Addendum No. 1 – Mexico Beach Pier

May 21, 2025

Project: Mexico Beach Pier – Non-mandatory Pre-Bid Minutes

7 PILASTER ELEVATION
1" = 1'-0"

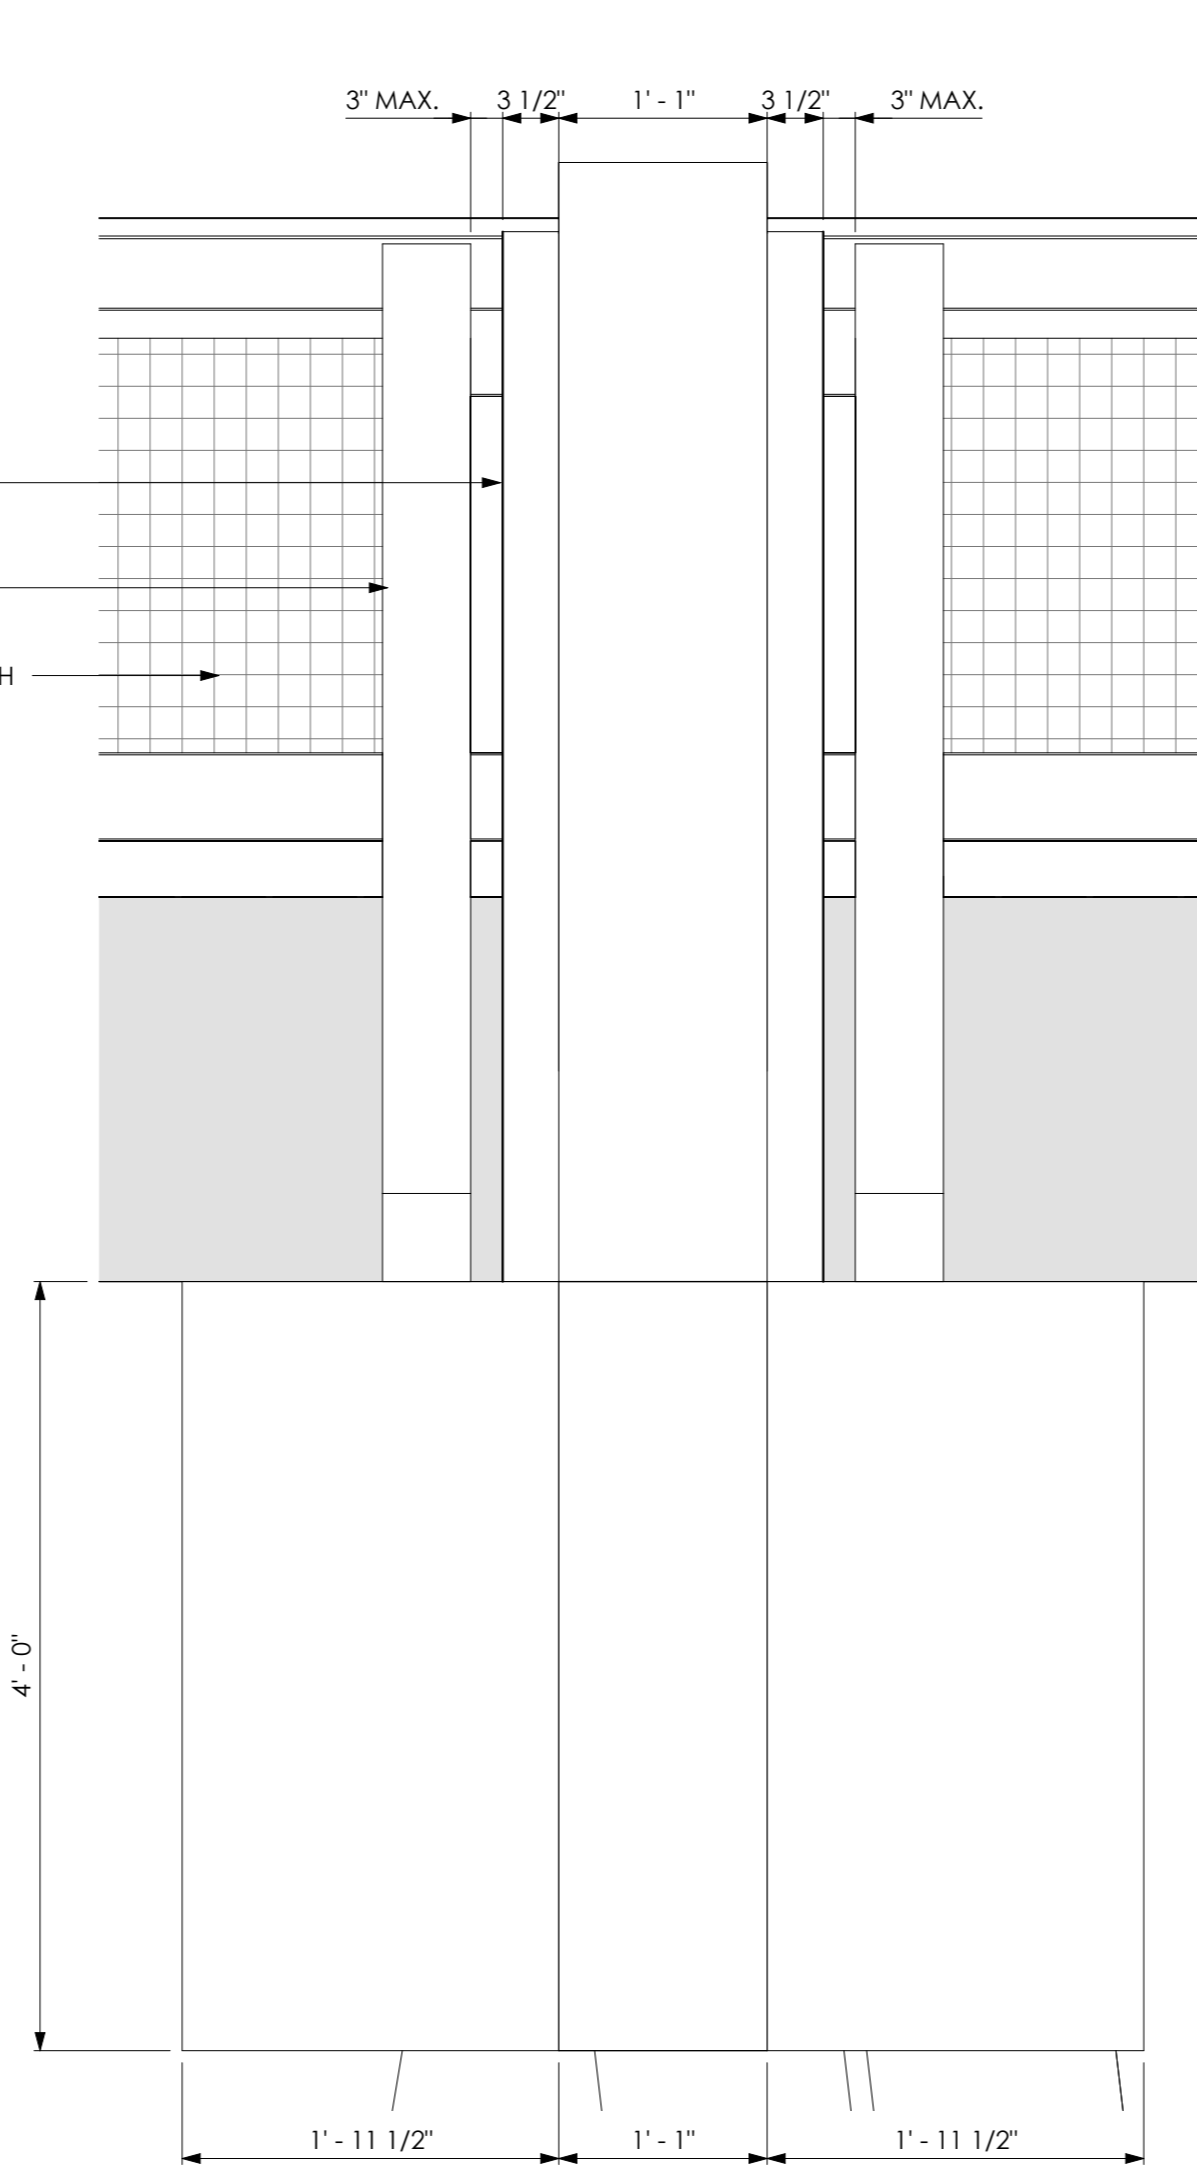
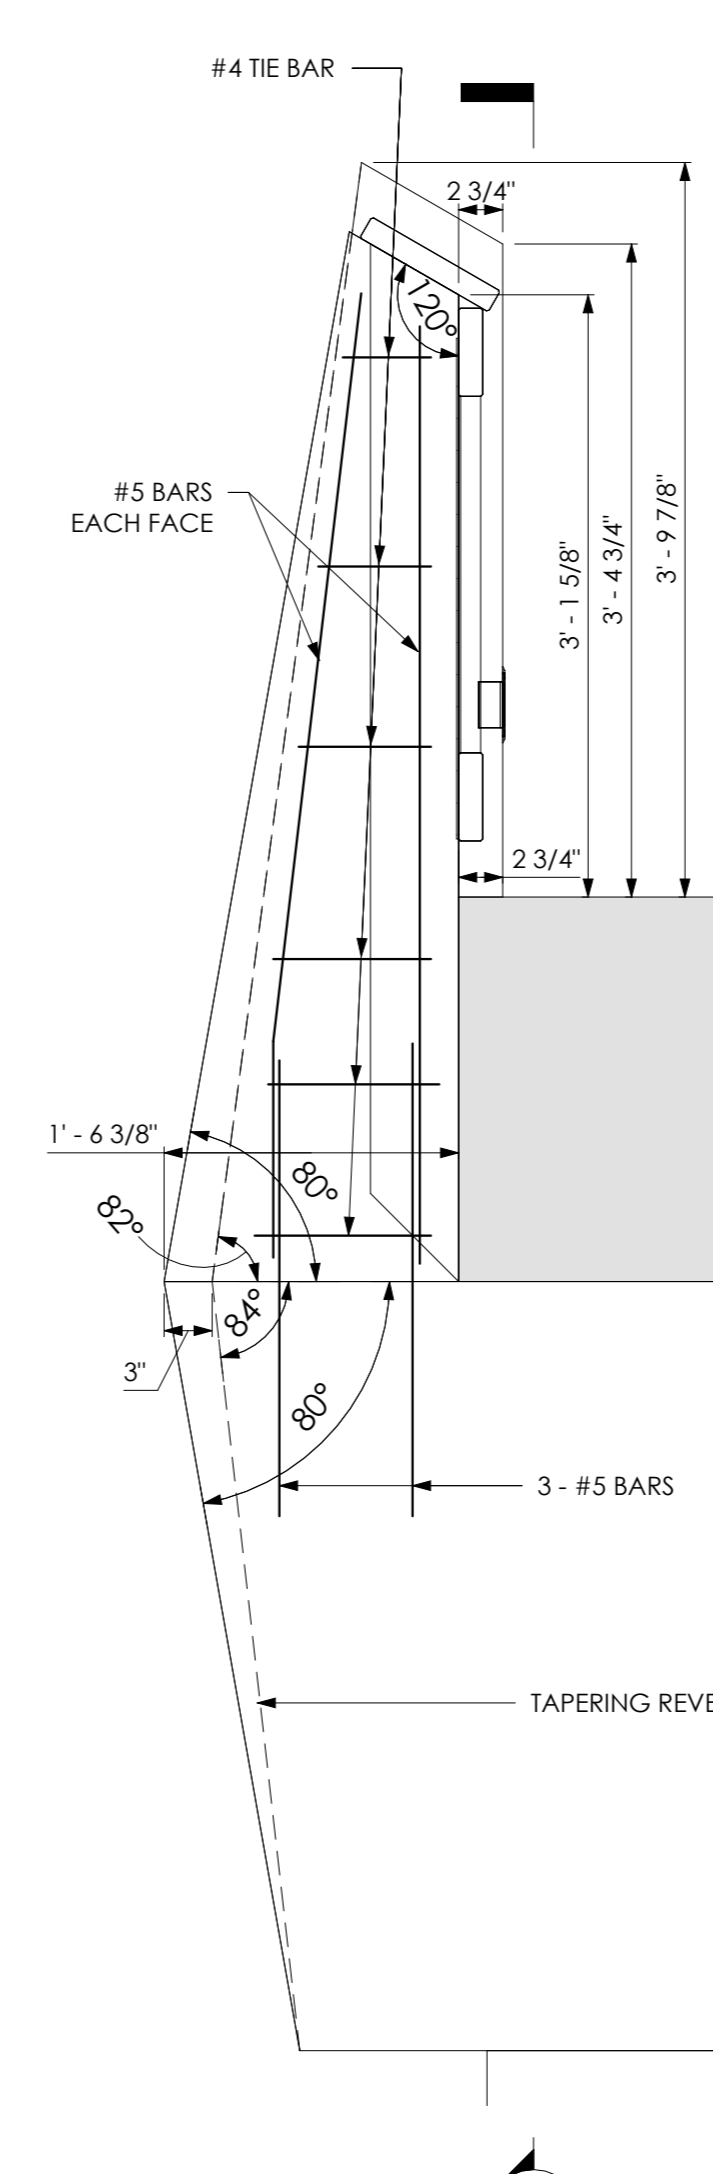
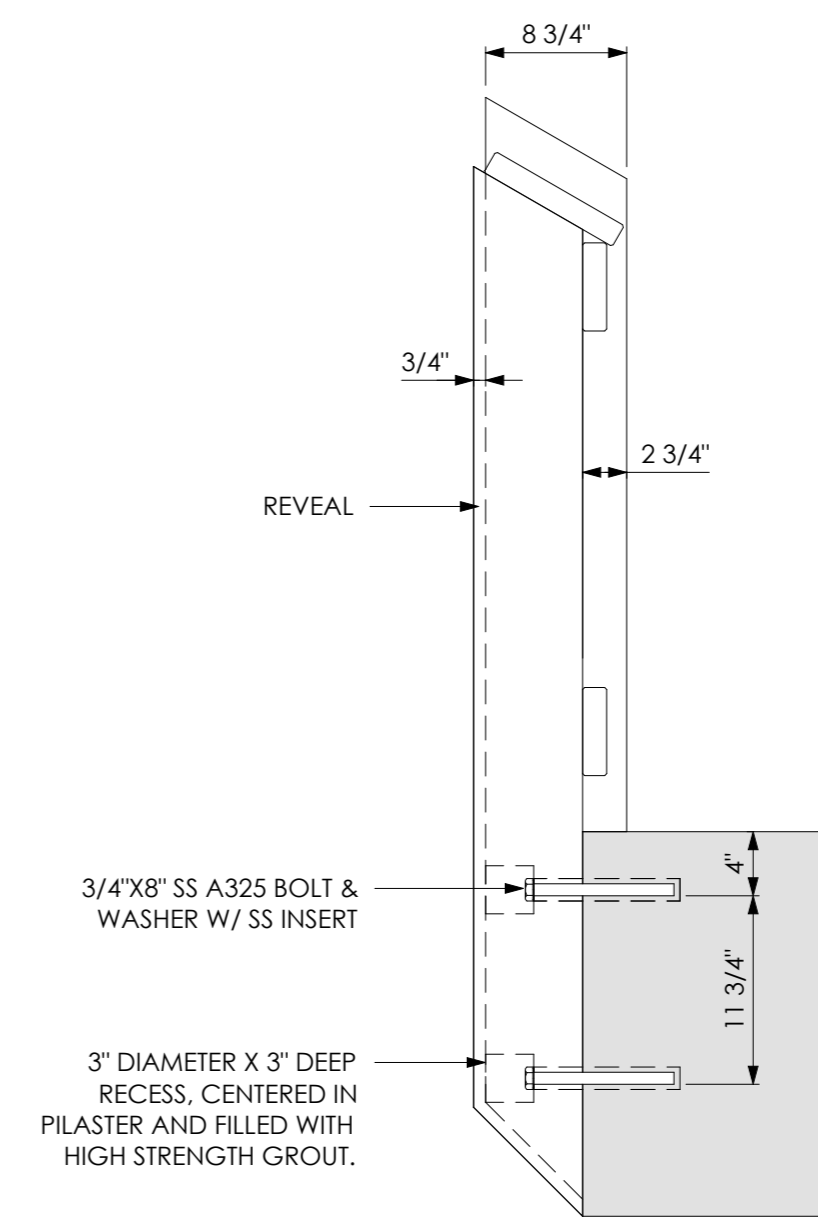
31. We see no detail on the pilasters incorporated into the guardrail? *See the revised detail for the pile cap / pilaster connection detail on sheet A-01.*

34. Sheet S102 detail B1 shows the concrete post to be 12” x 18” and detail A1 shows the post to be 12” x 20”. What is the correct size? *See the revised detail for the pile cap / pilaster connection detail on sheet A-01.*

35. Please provide a detail on the concrete post. *See the revised detail for the pile cap / pilaster connection detail on sheet A-01.*
36. Please provide how the concrete post attaches to the concrete cap. *See the revised detail for the pile cap / pilaster connection detail on sheet A-01.*

67. Please provide reinforcing details for pilasters. *See A-01 for revised details.*

71. Please provide fastening/connection details for the timber handrail. *See A-01 for revised details.*

86. Sheet S-105, detail A7 depicts the pilasters setting directly on top of the cap, the architectural drawings depict the pilaster being cast into the outside face of the cap. The architectural details will add significant costs to the project. Please clarify. *The pilasters will sit on top of the beam. See Sheet A-01*

1 BUILDINGS PLAN
1/4" = 1'-0"

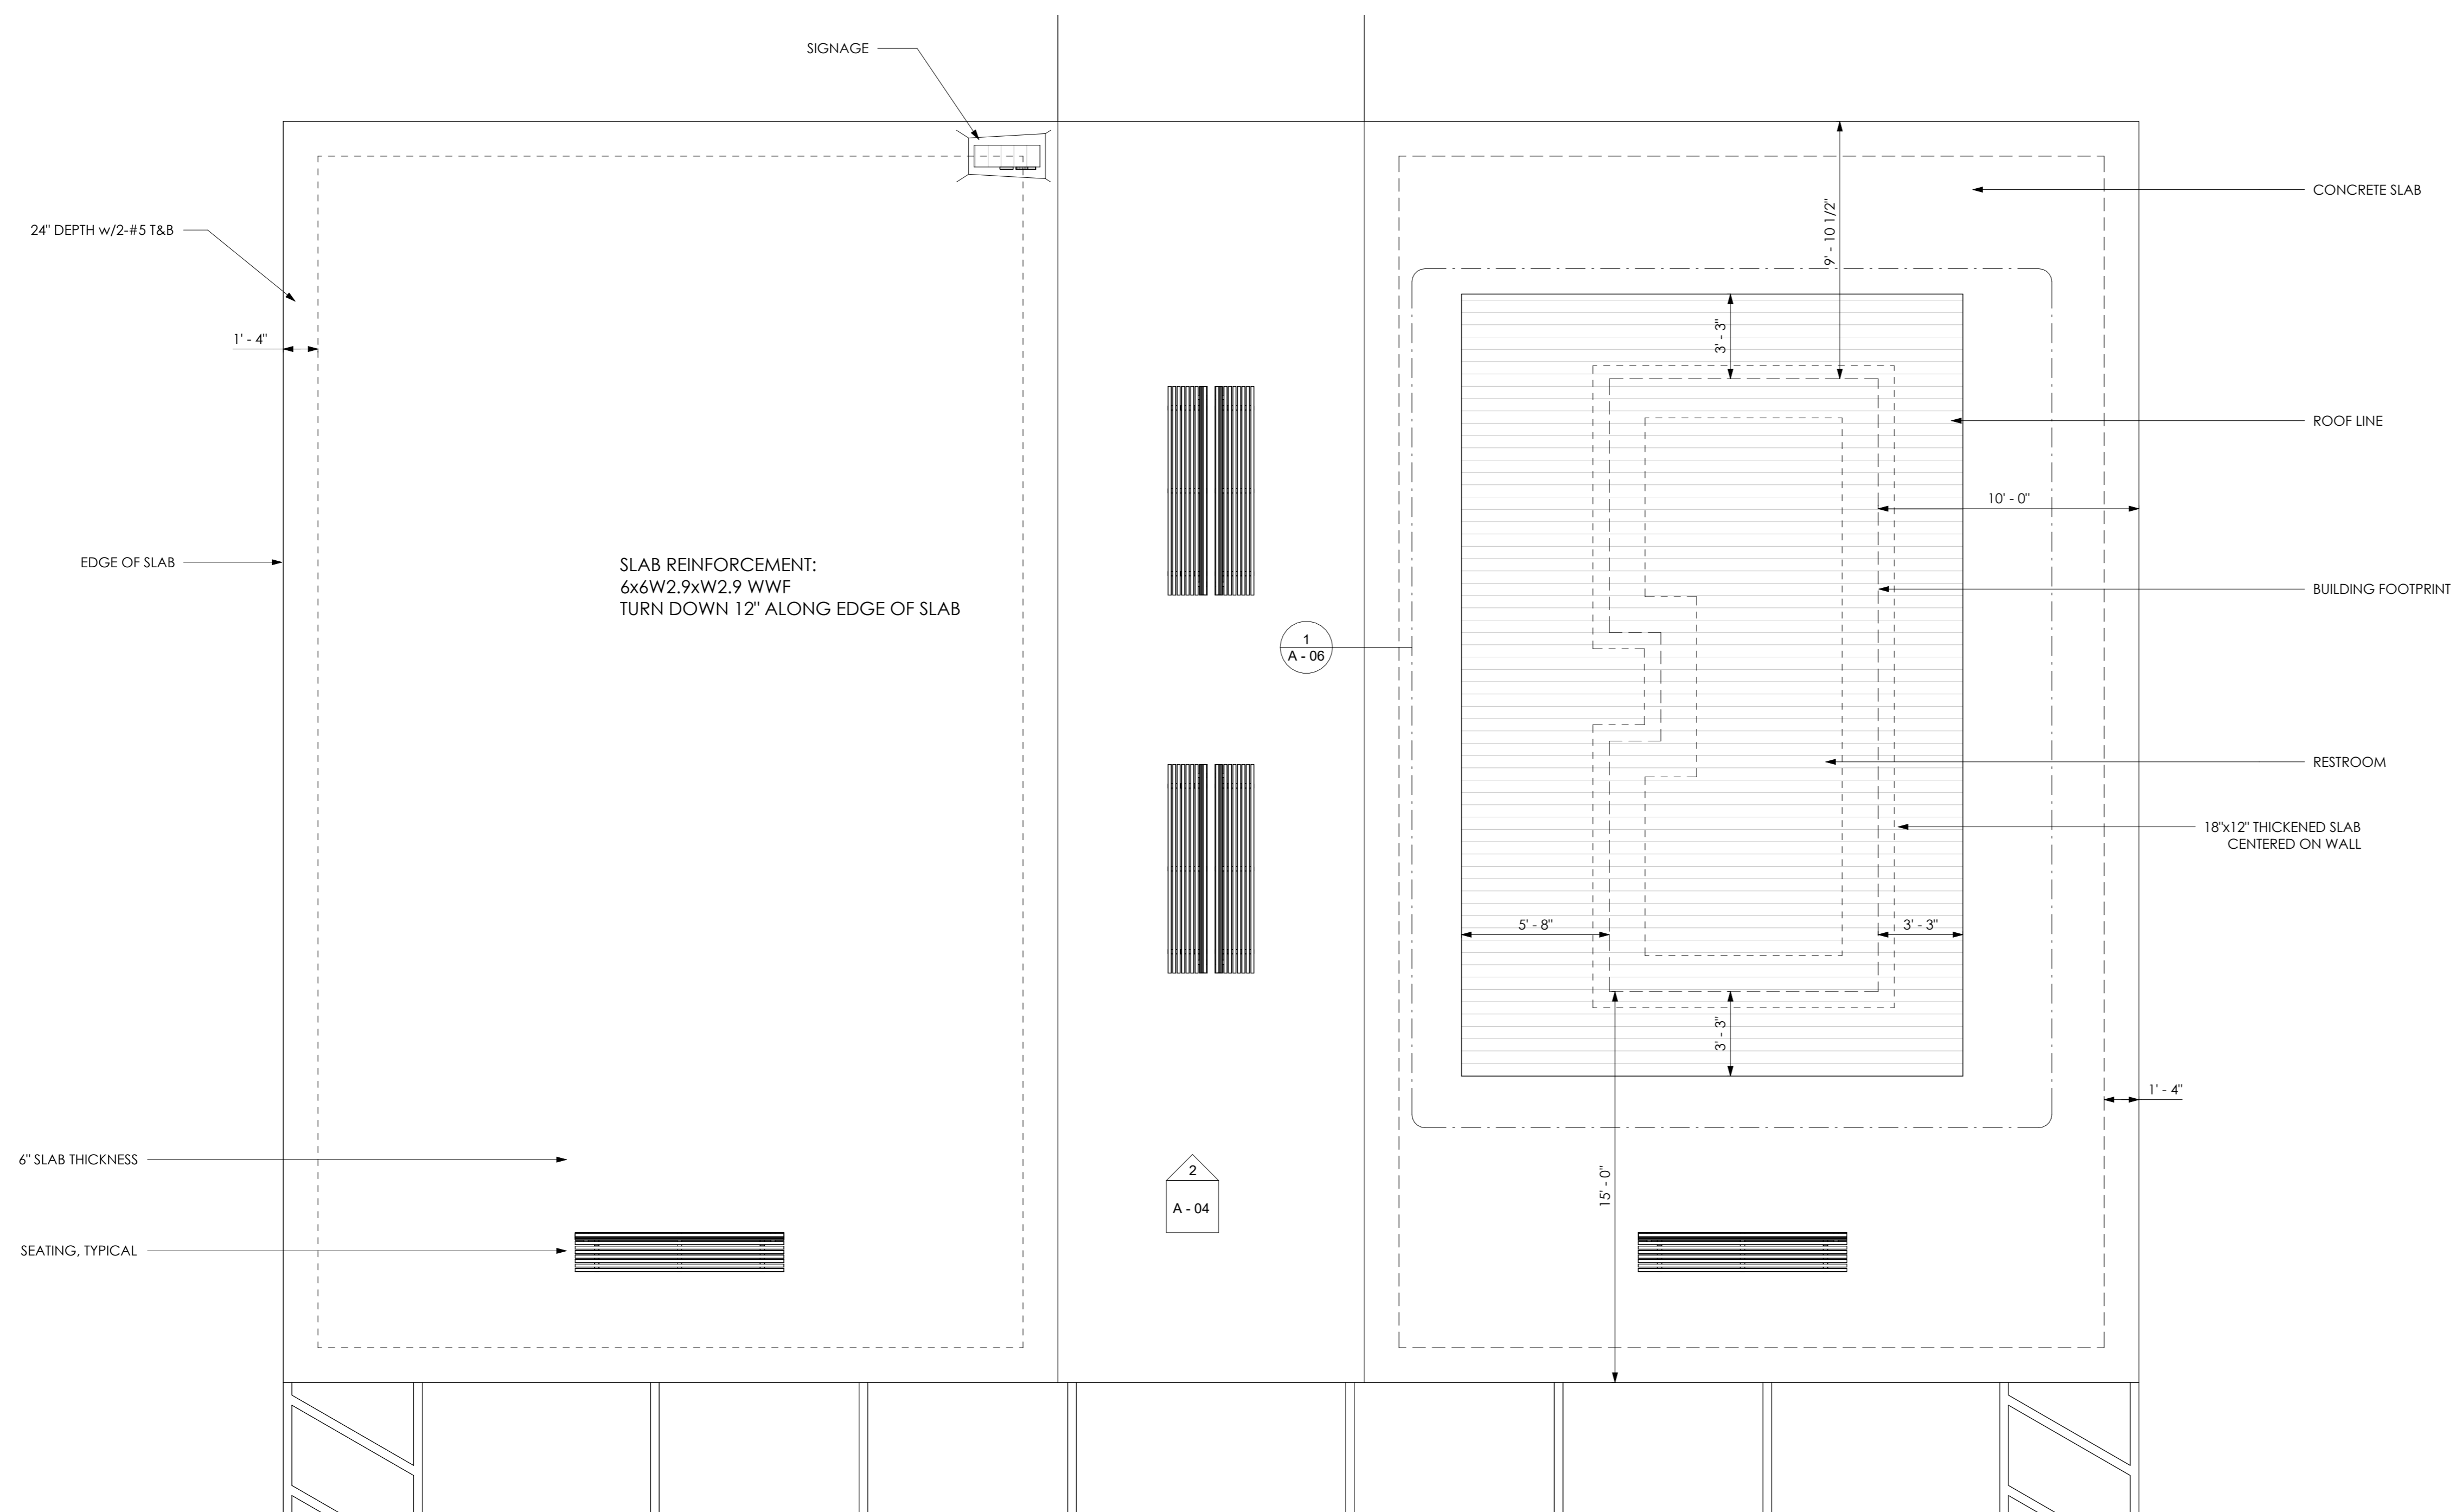
64. Please provide details of outdoor shower and its location, *See the attached change to the restroom to include a shower on the side of the building.*

65. Please provide updated plumbing details if necessary. *See the revised Architectural drawings for the shower located on the side of the restroom. All plumbing shall be copper piping.*

88. Sheet A-04 depicts a single structure on the building plan located on the west side of the pier's access with a thickened slab on the east side of the pier access ramp. Sheet C-103 indicates a single building to the east side of the ramp with no slab or structure to the west side. Sheet E-211 depicts two structures in this same area. Please clarify the area around the restrooms. *One restroom required for this project. See the answer to No. 63*
